## Detailed Site Plan

**DSP-15039**

| Application  | General Data                 |               |
|--|------------------------------|---------------|
| <b>Project Name:</b><br>Day Care Center at 6000 Marlboro Pike<br><br><b>Location:</b><br>Northeast quadrant of the intersection of Marlboro Pike and Belwood Street<br><br><b>Applicant/Address:</b><br>Rosbor, Tillie<br>13616 Hollow Log Drive<br>Upper Marlboro, MD 20774 | Planning Board Hearing Date: | 12/15/16      |

SUBJECT: Detailed Site Plan DSP-15039  
Day Care Center at 6000 Marlboro Pike

# SITE PLAN

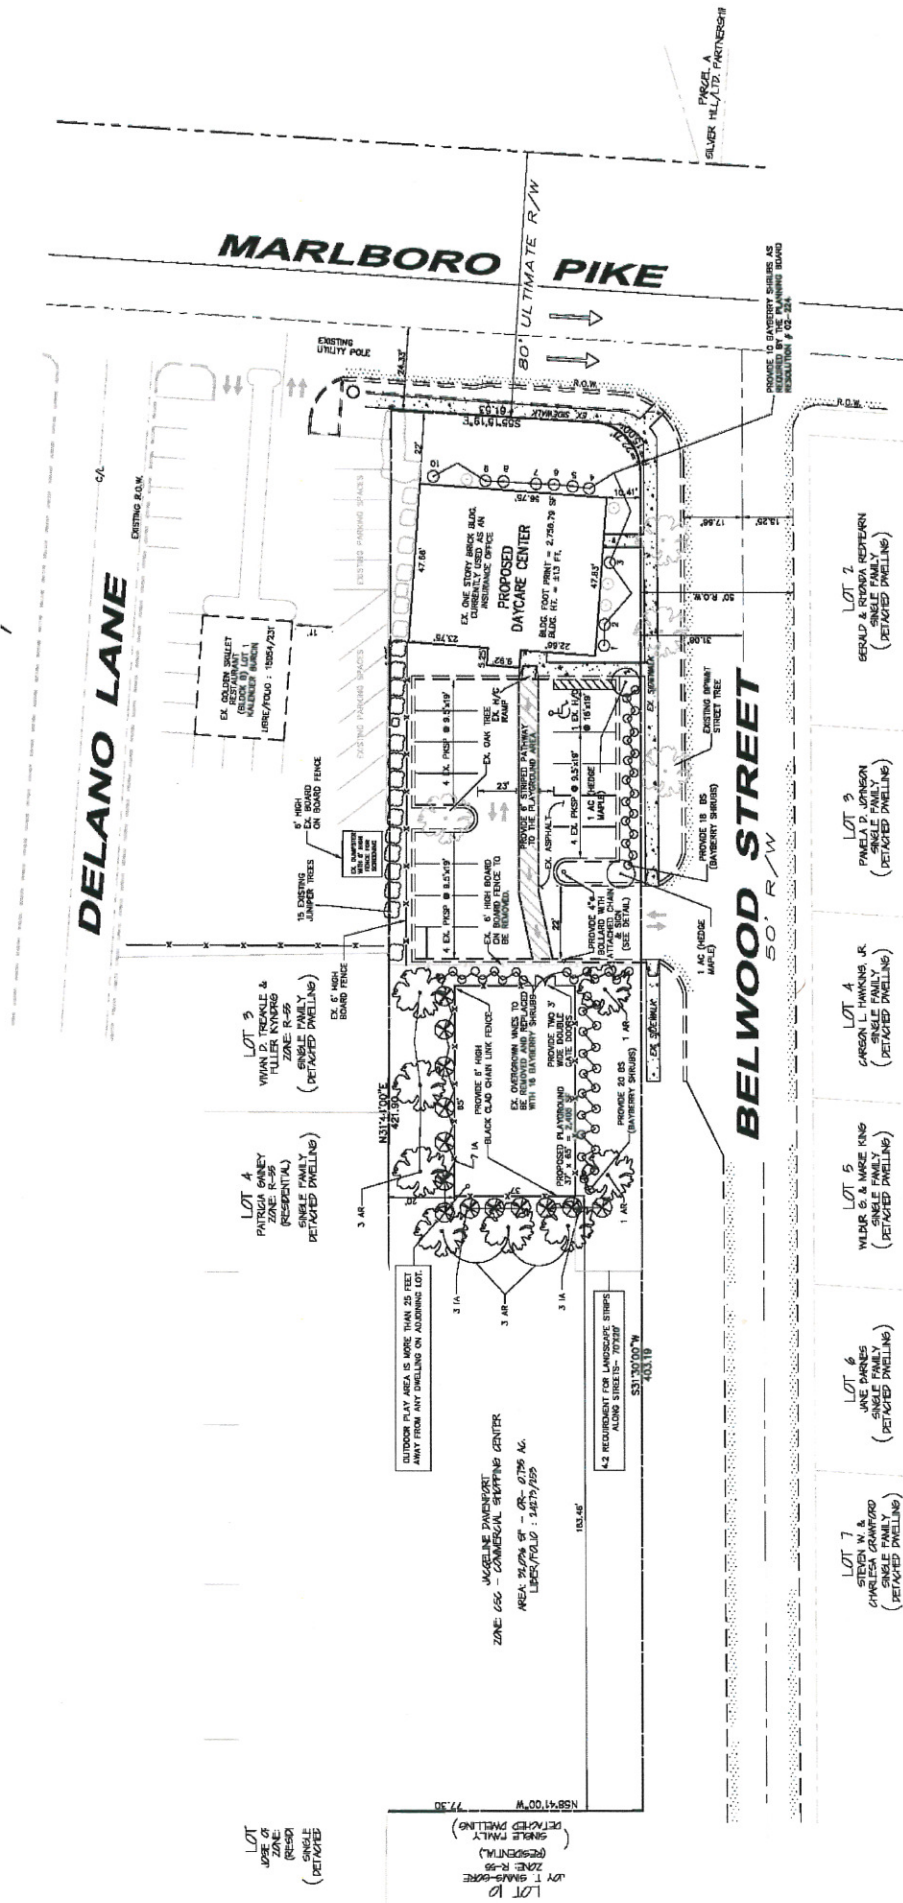
**Comment:** The General Notes indicate the proposed enrollment. The site plan does not indicate the location of all adjacent buildings on the adjacent lots as required in Subpart (ii) above. The site plan should be revised to show the location of all buildings on adjoining lots. A condition is included in the Recommendation section of this report to address this concern. The location and size of the outdoor play area are indicated as required by Subpart (iii) above, and the location, quantity, and type of screening are located in accordance with Subpart (iv) above.

- a. **Section 4.2, Landscape Strips Along Streets**—Applies to all public and private road frontages, which includes that portion of Belwood Street in the current application not included in previous approvals. The applicant should revise the plan to show a ten-foot-wide planted landscape strip in accordance with this section. Staff specifically recommends that evergreen trees be provided parallel to the northern boundary of the play area for additional screening.

- b. **Section 4.7, Buffering Incompatible Uses**—Requires that a buffer be provided between adjacent incompatible land uses. The applicant has provided Section 4.7 schedules for the eastern and southern boundaries of the play area rather than the entire length of property boundary not included in prior approvals. It appears that existing trees may fulfil planting requirements along the southern property line and a portion, if not all, of the eastern property line. The applicant should revise the plan to label the 4.7 bufferyard limits and widths, show the existing tree line, and adjust the 4.7 calculations and proposed plantings accordingly.

- c. **Section 4.9, Sustainable Landscaping Requirements**--Requires that certain percentages of native plants be provided on-site, along with no invasive plants and no plants being planted on slopes steeper than three-to-one. Because additional plantings are proposed and required, a schedule for Section 4.9, Sustainable Landscaping Requirements should be provided. It is noted that the previously-approved Barberry shrub is an invasive species. Staff recommends that any dead Barberry shrubs be replaced with a native, non-invasive plant species.

1. Prior to certification of this detailed site plan (DSP), the following revisions shall be made or information provided:
  - a. A striped crosswalk shall be provided across the entrance driveway, along Belwood Street.

- b. Provide site plan notes as follows:
    - (1) Indicate the play area is more than 25 feet from any dwelling on an adjoining lot.
    - (2) “Resilient flooring in accordance with the standards of the American Society for Testing and Materials (ASTM) shall be provided in the proposed outdoor play area where play equipment will be installed.”

- (3) “Grading of the outdoor play area shall ensure complete drainage of any stormwater from the play area.”
  - c. The site plan shall be revised to show the location of all buildings on adjoining lots.

- d. Provide the allowed and provided sign area calculations per Section 27-617 of the Zoning Ordinance and indicate the location of the building-mounted sign on the building elevation.

- e. Show a ten-foot-wide planted landscape strip along Belwood Street in accordance with Section 4.2 of the Landscape Manual. Six evergreen trees shall be provided in a staggered line in partial fulfillment of Section 4.2 requirements to screen the play area.

- f. Revise the plan to label the 4.7 bufferyard limits and widths, show the existing tree line, and adjust the 4.7 calculations and proposed plantings accordingly.
- g. Provide a schedule for Section 4.9, Sustainable Landscaping Requirements. Any dead Barberry shrubs shall be replaced with a native, non-invasive plant species.
